QUALITY ASSURANCE -- NON-CONFORMANCE REPORT

Report No: NCR-000829

Reference Description: Heat Straightening without Engineer's Approval on CB3002D-018-002 (CB18)

Dear: Mr. Charles Kanapicki
Job Name: SAS Superstructure

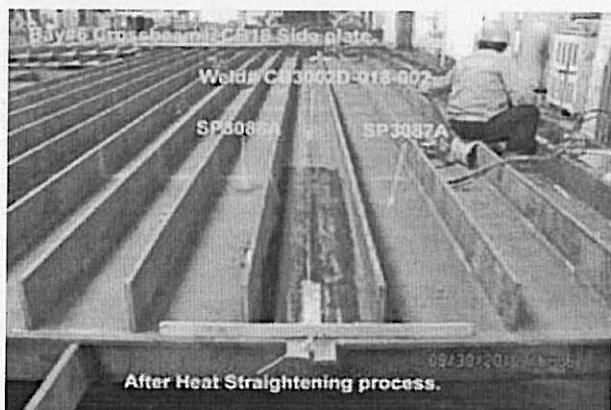
During Quality Assurance (QA) in-process observations of the fabrication of Crossbeam CB18 Side plates, QA discovered the following issue:

-ZPMC personnel have performed heat straightening excessive distortion on one of the side panels for CB18 without Engineers approval.

-Distortion measured 12mm per 1000mm.

-The weld is identified as CB3002D-018-002.

-The weld is CJP butt joint, joining Side plate (SP3087A) to Side plate (SP3088A).

-The Material thickness is 20 mm.

-This side panel is located in Sub assembly Bay#6.

For further information, please see the attached pictures below.

Contractor will repair the location with the excess amount of distortion. Contractor will issue an internal NCR to the workers to avoid the similar future occurrence.

Contractor repaired the location with the excess amount of distortion. Contractor issued an internal NCR to the workers to avoid the similar future occurrence.
